FURTHER REPORT - JRPP PLANNING REPORT

JRPP NO:	2013SYW007
DA NUMBER:	DA 658/2013/JP
LOCAL GOVERNMENT AREA:	THE HILLS SHIRE COUNCIL
PROPOSED DEVELOPMENT:	PROPOSED MIXED USE DEVELOPMENT INCLUDING RESIDENTIAL FLAT BUILDINGS, RESTAURANTS, CHILD CARE CENTRE, BUSINESS PREMISES, SHOPS, INDOOR RECREATION, PARKING AND LANDSCAPING.
STREET ADDRESS:	LOT 1 DP 136011, NO. 636 OLD NORTHERN ROAD, DURAL
APPLICANT/OWNER:	PALLADIUM PROPERTY
NUMBER OF SUBMISSIONS:	ONE
RECOMMENDATION:	APPROVAL
REPORT BY:	TOWN PLANNING CO-ORDINATOR ROBERT BUCKHAM

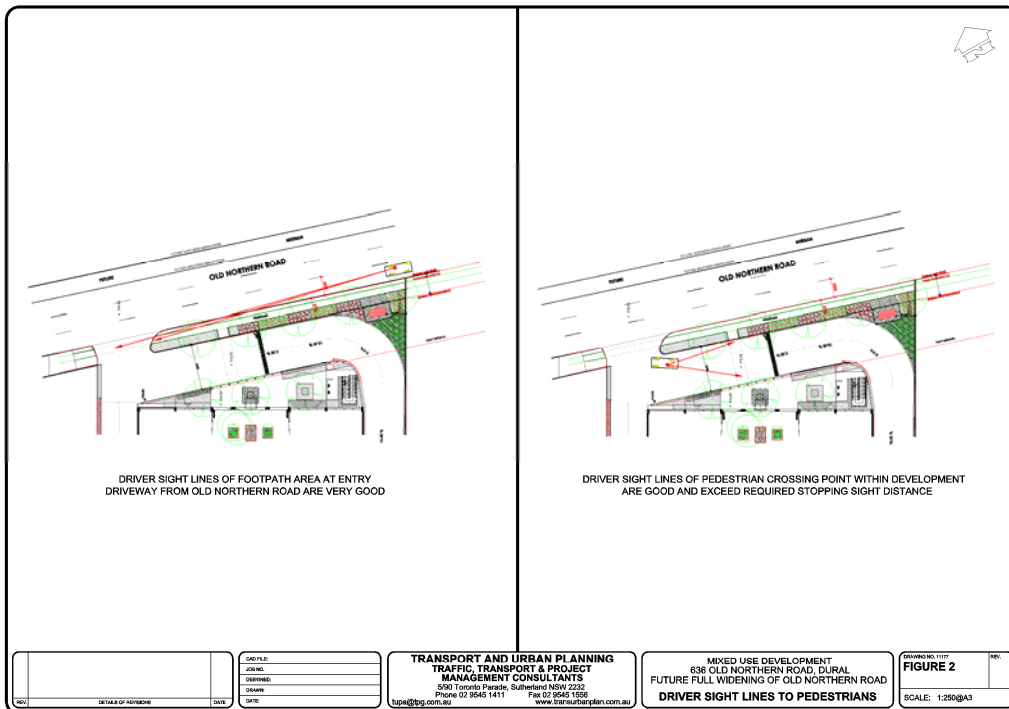
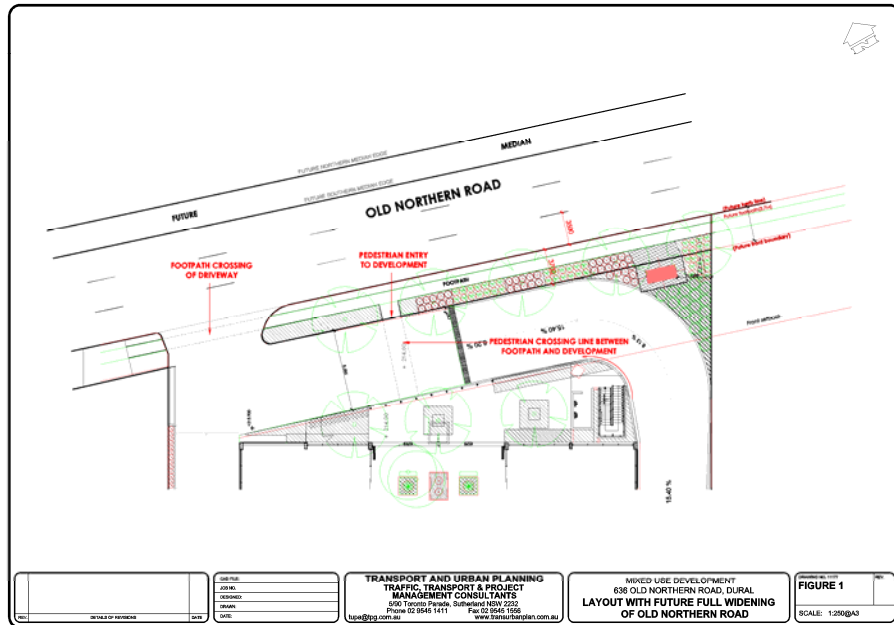
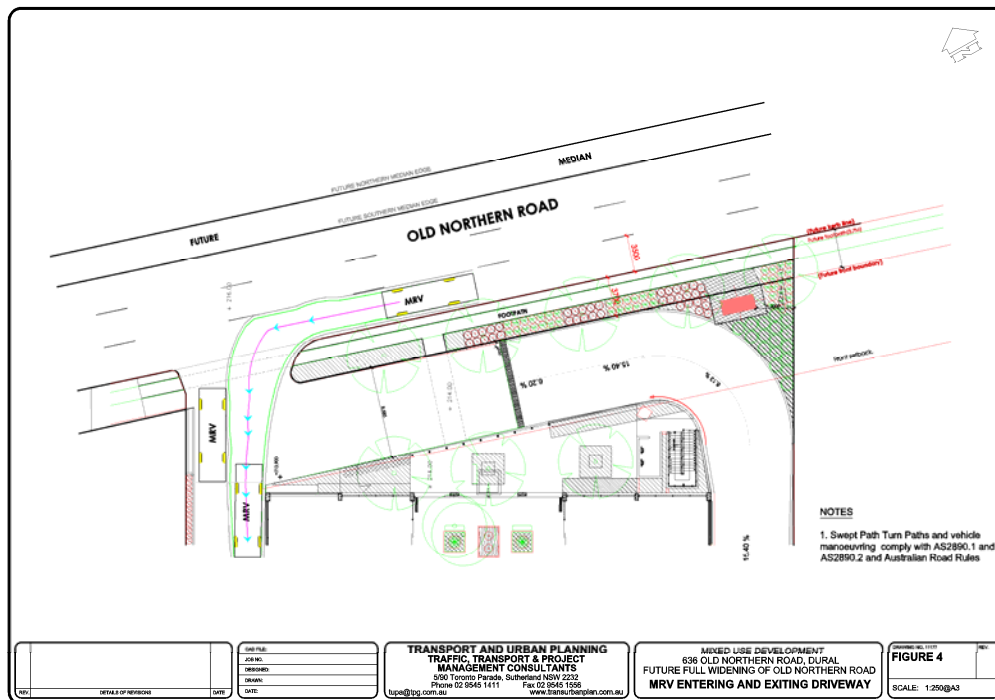
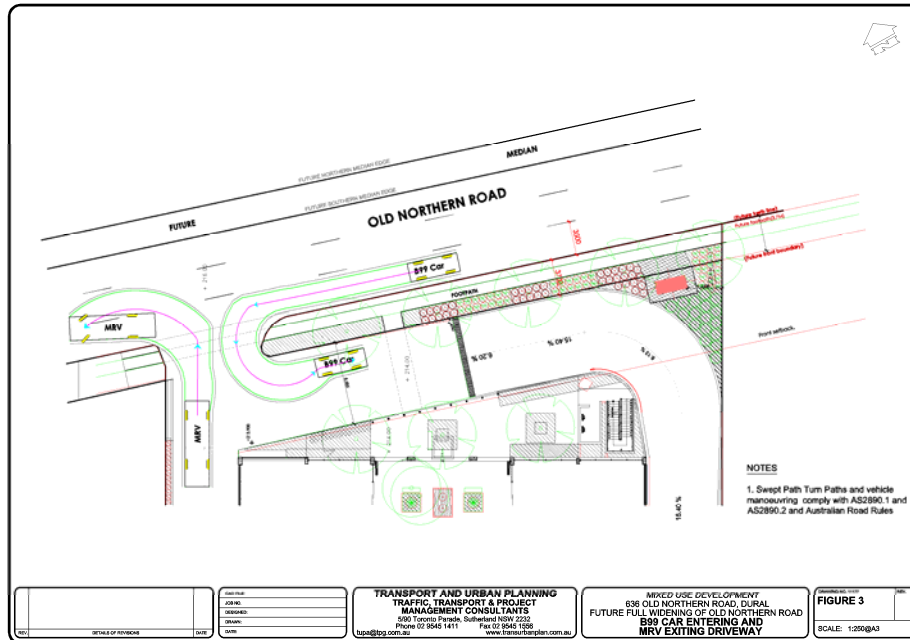
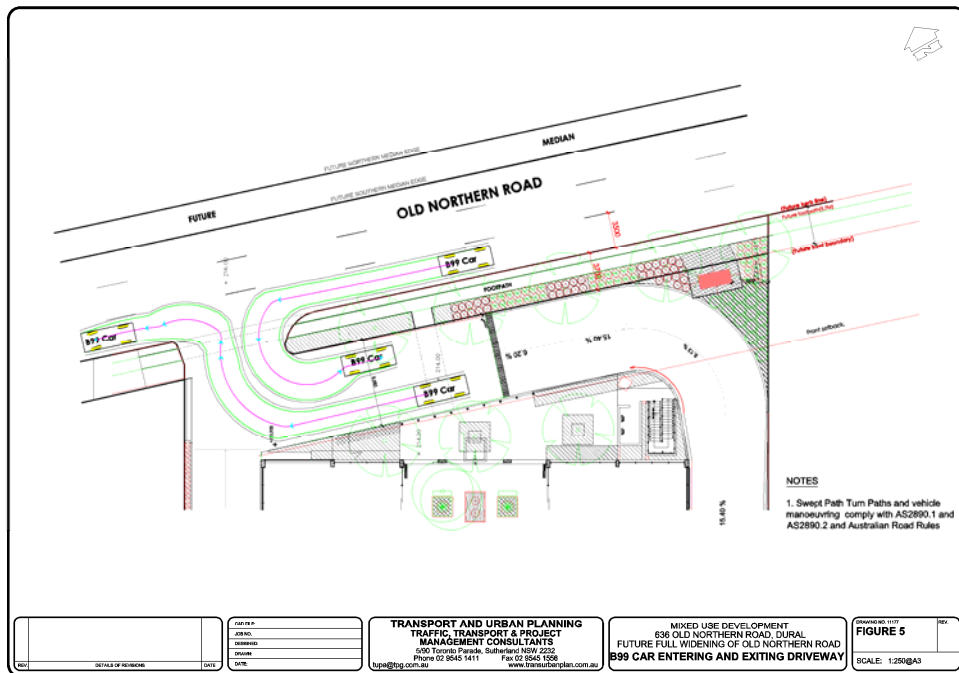
Figure 1 shows the driveway to the proposed development together with the pedestrian footway along Old Northern Road and the pedestrian entrance to the development from Old Northern Road footpath. The pedestrian entrance to the development is separated from the vehicle driveway and is located southwest of the vehicle driveway. Where the footpath crosses the driveway in Old Northern Road drivers/vehicles entering and exiting the development are required to give way to pedestrians using the footpath.

Vehicles entering the driveway from Old Northern Road would turn left into the driveway from the kerbside lane and vehicle speeds would be typically 10km/h or less (ie. 5-10km/h) when crossing the footpath. Drivers will have unobstructed sight lines of the footpath on either side of the driveway and the driveway and as noted above are required by law, to give way to pedestrians using the footpath in Old Northern Road. **Figure 2** shows the driver sight lines to driveway from Old Northern Road.

Within the development site and where pedestrians would cross the internal road, a lower 10 km/h speed limit will be provided together with appropriate pedestrian facilities such as a shared zone or similar, requiring drivers to give way to pedestrians. These proposed measures on the internal road will ensure that pedestrian amenity and potential pedestrian safety will be maintained. Sight distance of the pedestrian crossing point is adequate for pedestrian safety (see **Figure 2**).

Transport and Urban Planning Pty Ltd has prepared swept path diagrams (**Figures 3 to 5**) of vehicles entering and exiting the site based on the two (2) design vehicles of a Medium Rigid Truck (ie. MRV Service Vehicle 8.8 metres long) accessing the loading dock area on the northern side of the site and a B99th car travelling to and from the internal road which traverses the southern side of the site and links to the car parks.

The swept path diagrams **Figures 3 and 5** show that the B99th car can easily undertake this manoeuvre and the vehicle speed for this manoeuvring would be similar to the desirable vehicle speed when a vehicle crosses the footpath (ie. 5km – 10km/h). The vehicle manoeuvring is fully in accordance with AS2890.1 and is considered to be satisfactory.

Under the Australian Road Rules and AS2890.1 and AS2890.2 vehicles turning out of a driveway can turn into any of the northbound traffic lanes, providing that it is safe to do so and are not required to turn into the kerbside lane only. Reference to **Figure 5** shows that the B99th car can turn left into the kerbside lane. This will be representative of the majority of vehicles (99%) exiting the site.

The MRV vehicle which is 8.8 metres long requires slightly more room due to its length, when turning out of the driveway, but can easily make the turn within the northbound carriageway. The number of MRVs turning out of the site would be in the order of 6-8 vehicles per day. The manoeuvring shown on **Figure 3** is fully in accordance with AS2890.2 requirements and is lawful under Australian Road Rules.

In summary the swept path diagrams shown on **Figures 3 to 5** confirm that future manoeuvring with the full widening of Old Northern Road would be satisfactory and would be fully in accordance with AS 2890.1 and AS2890.2 requirements, as well as the Australian Road Rules.

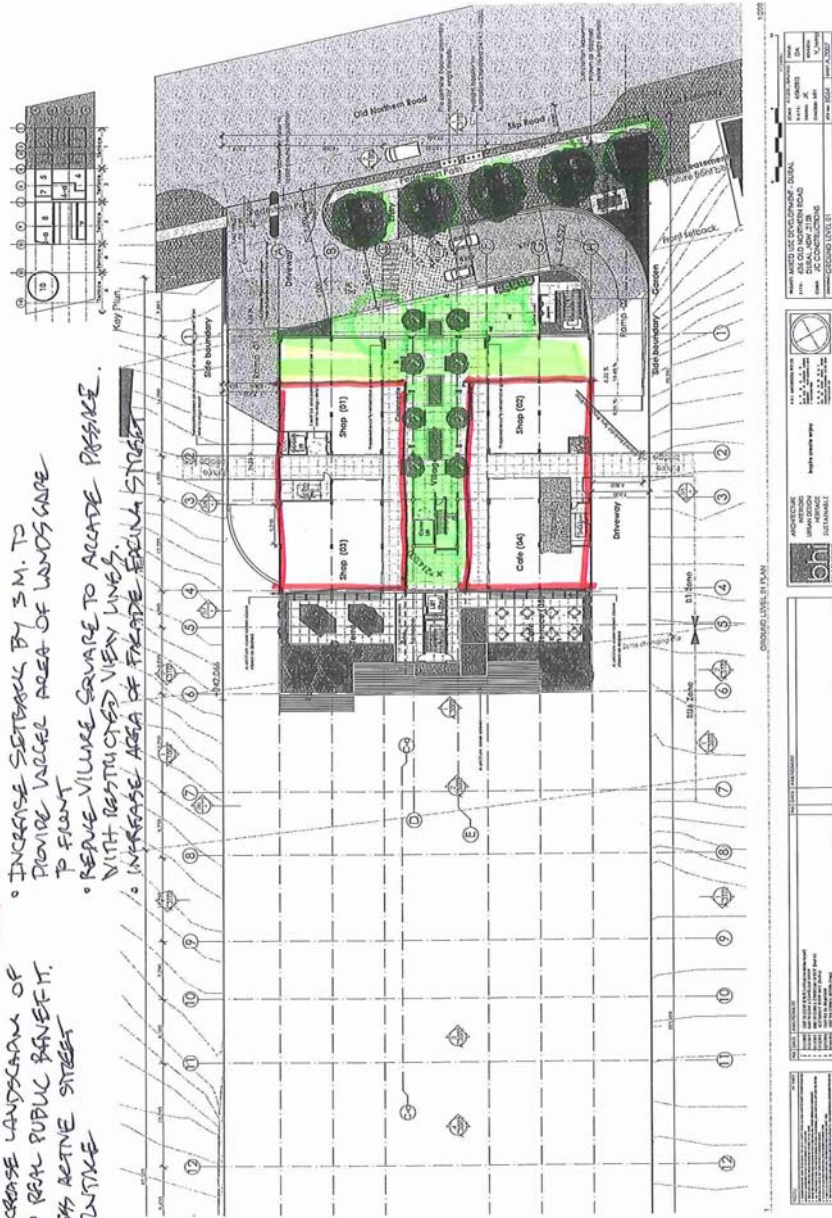
- 2. OPTION 1**
- INCREASE LANDSCAPE OF NO REAL PUBLIC BENEFIT.
 - LEAVE RETAIL STREET FRONT
 - INCREASE SETBACK BY 3 M. TO PROVIDE LARGER AREA OF LANDSCAPE TO FRONT
 - REMOVE VILLAGE SQUARE TO ACUTE PASSAGE WITH RESTRICTED VIEW LINES.
 - INCREASE AREA OF FRONT SETBACK STREET

3. OPTION 2

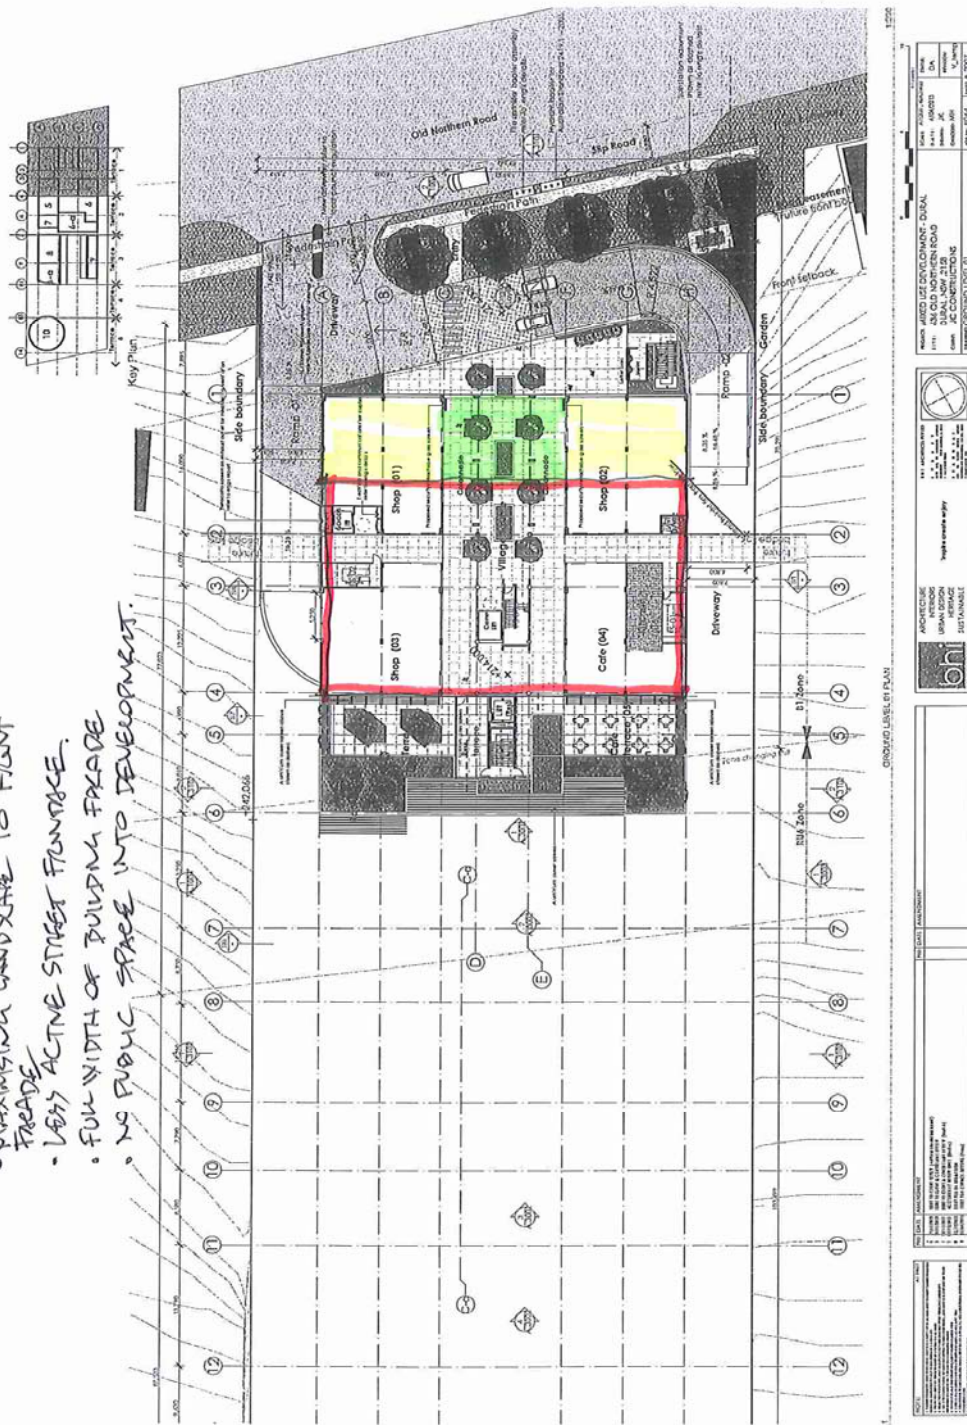
- MAXIMISING LANDSCAPE TO FLUNT FACADE
- LESS ACTIVE STREET FRONTAGE
- FULL WIDTH OF BUILDING FACADE
- NO PUBLIC SPACE INTO DEVELOPMENT.
